FCC Class II Permissive Change Request Letter

Date: Dec. 02, 2021

**RE: FCC Permissive II Change Request for Company: Swann Communications Pty Ltd,
FCC ID: VMISWIFIXTRCAM**

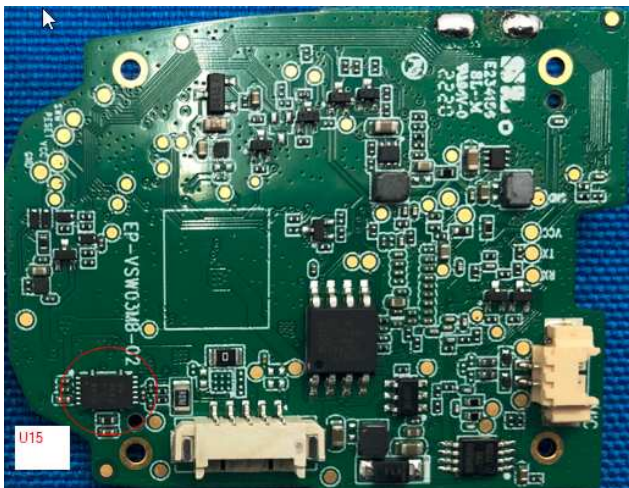
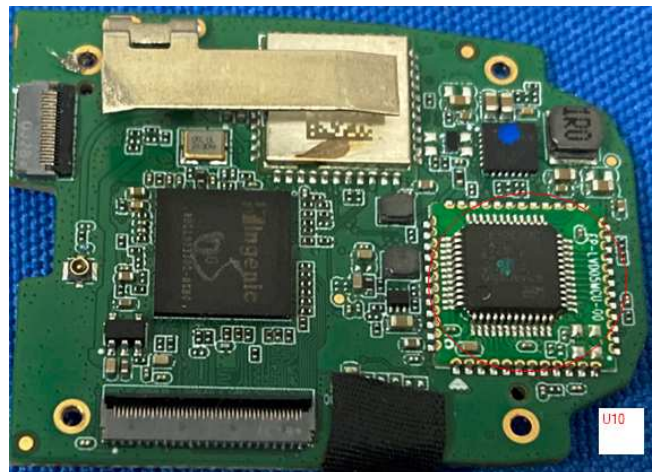
We are submitting an application for a class II permissive change to the FCC approval of the Company name: Swann Communications Pty Ltd, product description: Xtream Wire Free Security Camera (FCC: **VMISWIFIXTRCAM**, Original Grant Date: 2020/10/20). The transmitter module itself has not changed. Here are the changes:

- 1) Changed the U10 from STM8K6U6 to GD32E230C8T6 as MCU
- 2) Changed the U15 from SON250X400X100P40-13 to SH366002R012RE as voltage regulator IC
